**GE Nuclear Energy**

ABWR

ABWR Review

Info. pertaining to  
RSW, MUWP, WECW, TCW and  
TSW

Figure 9.2-6a TURBINE COOLING WATER SYSTEM DIAGRAM

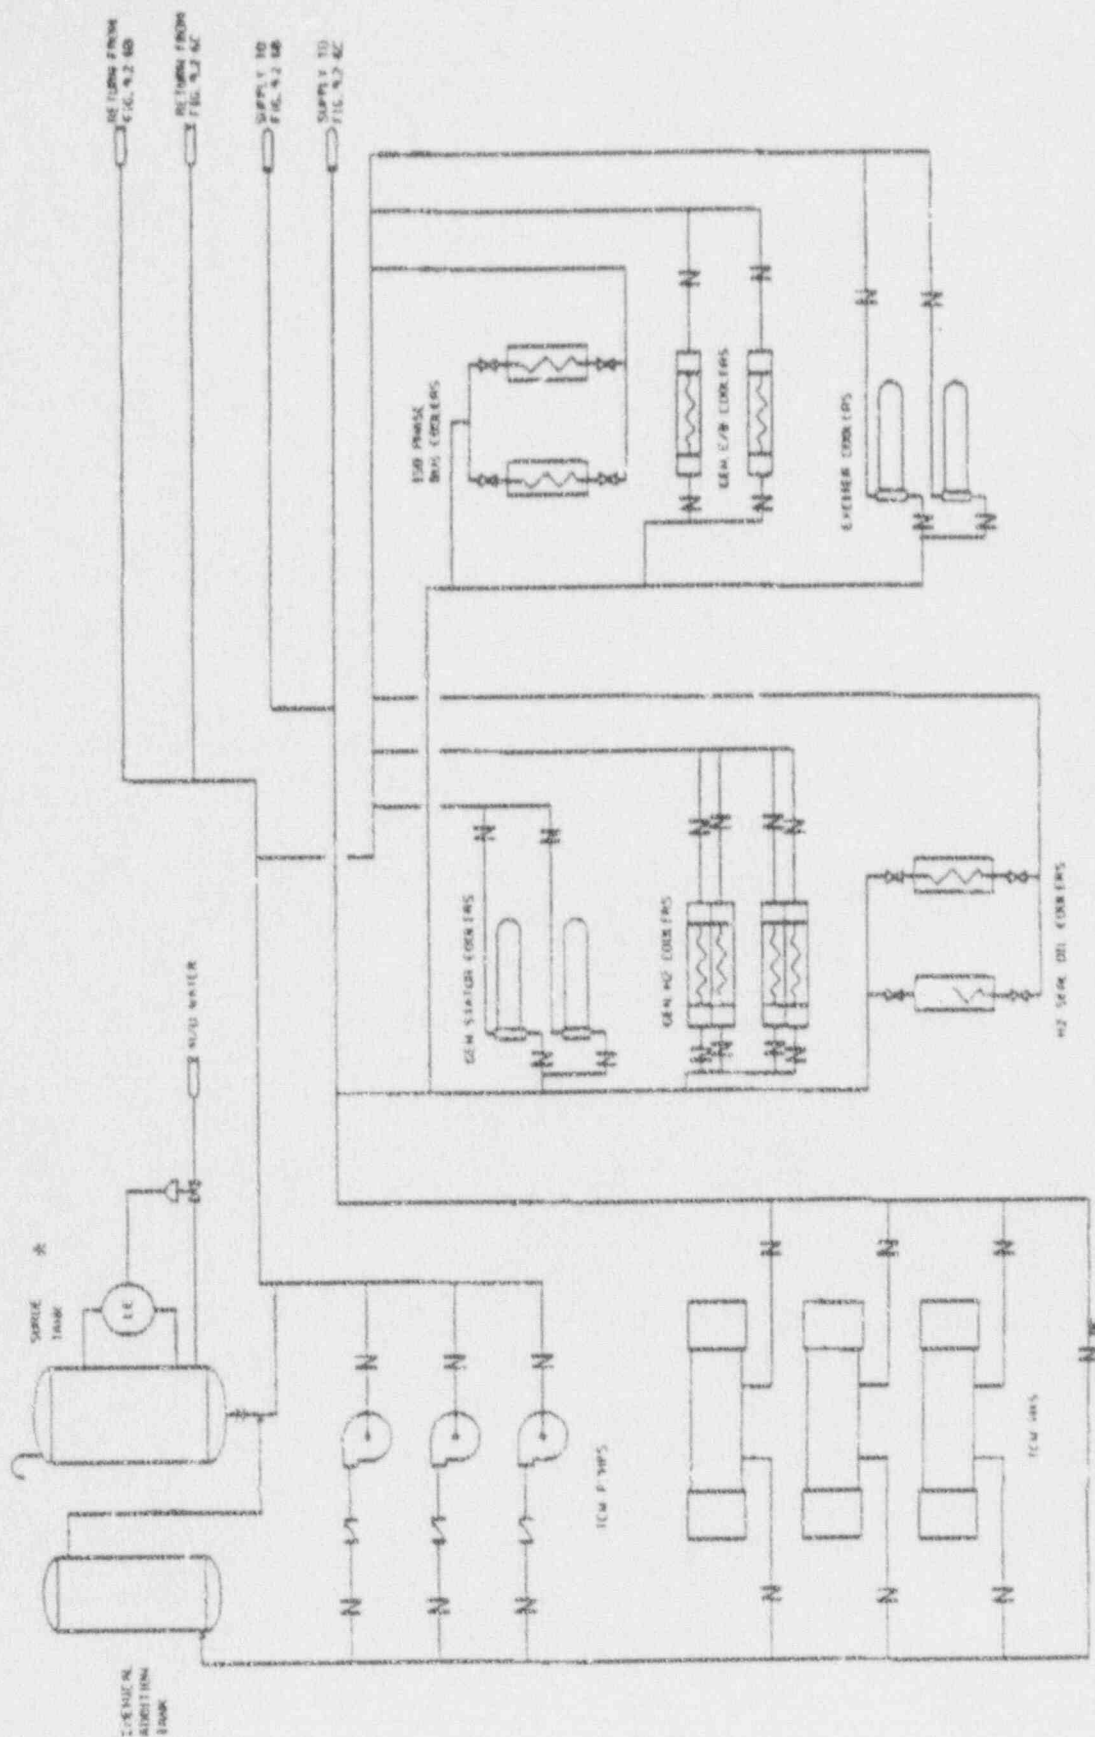
During normal power operation, <sup>two</sup> ~~one~~ of the ~~three~~ capacity TCW system pumps circulate

*two of the three 50*

three pumps with a capacity of 15,000 gpm each,  
three heat exchangers with heat removal capacity  
of  $65 \times 10^6$  Btu/h each,

Figure 9 2-8 TURBINE SERVICE WATER SYSTEM

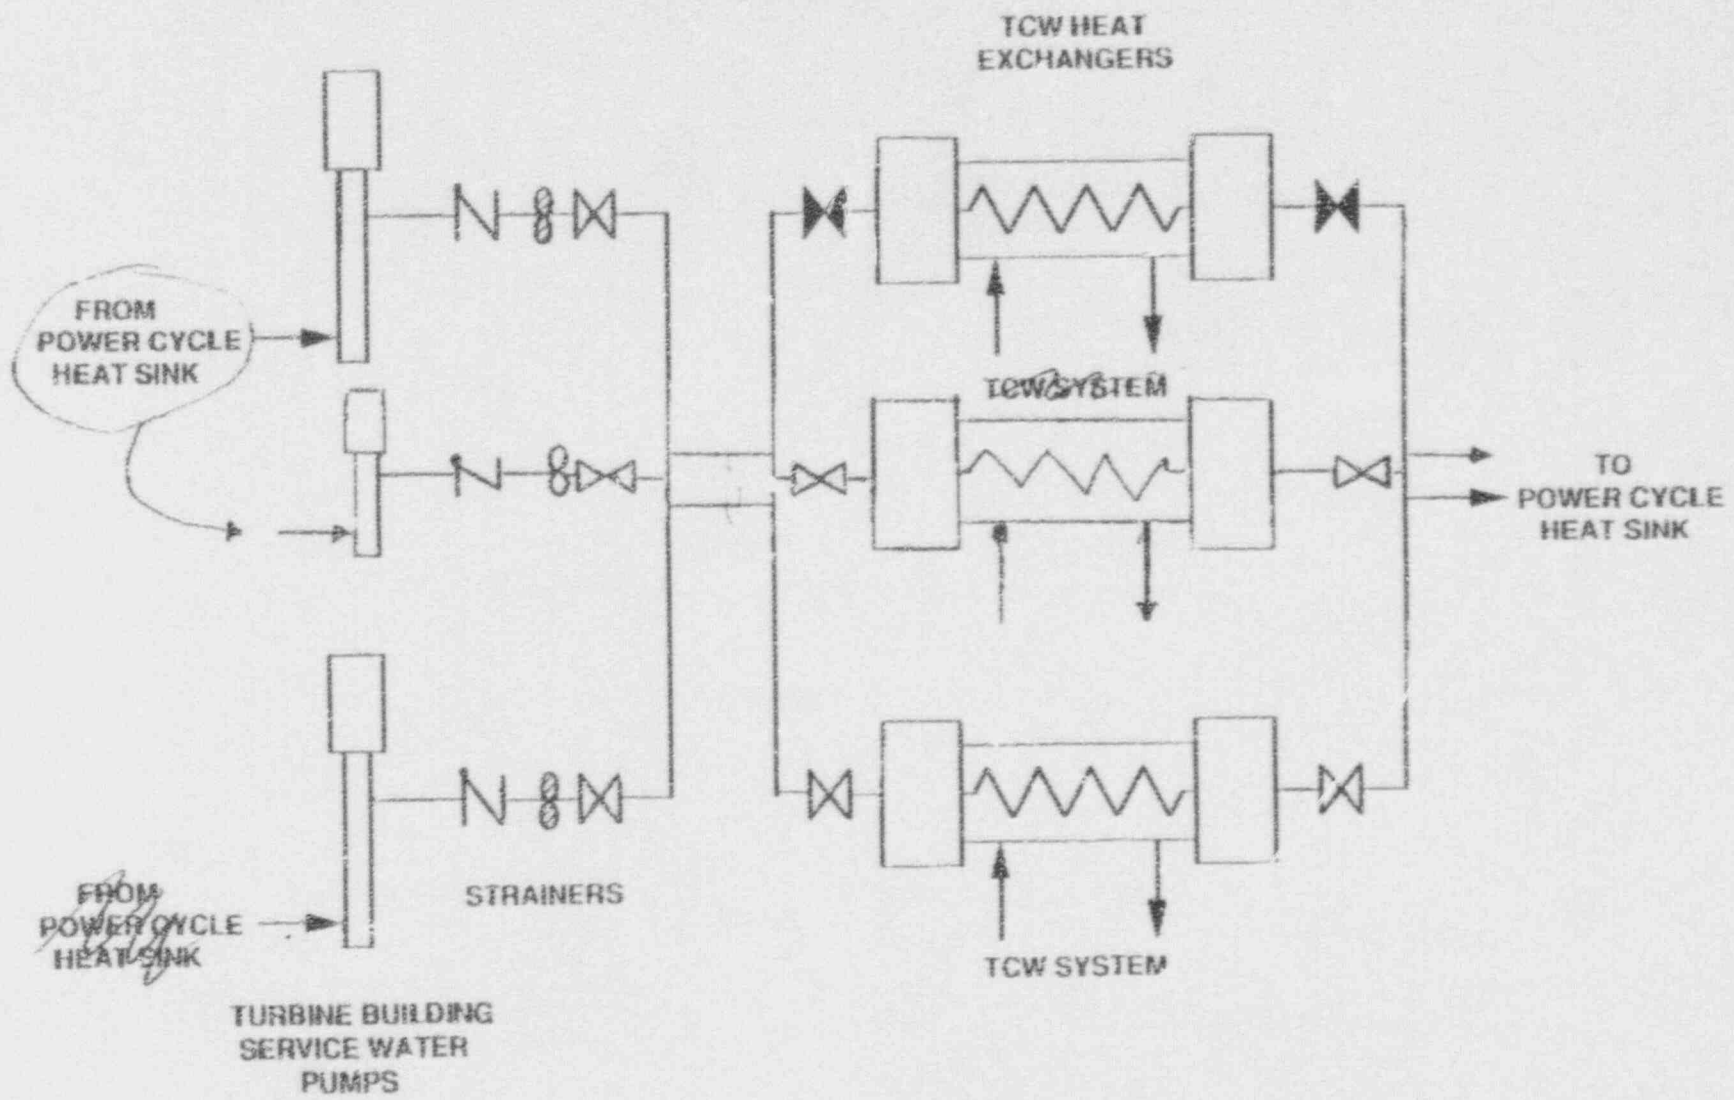
⑤ → 9.2.16.2 Portions Outside Scope of ABWR Standard Plant

All portions of the TSW system that are outside the turbine building are not in the scope of the ABWR Standard Plant. Sections 9.2.16.2.1 through 9.2.16.2.5 provide a conceptual design of these portions of the TSW system as required by 10CFR52. The interface requirements for this system are part of the design certification.
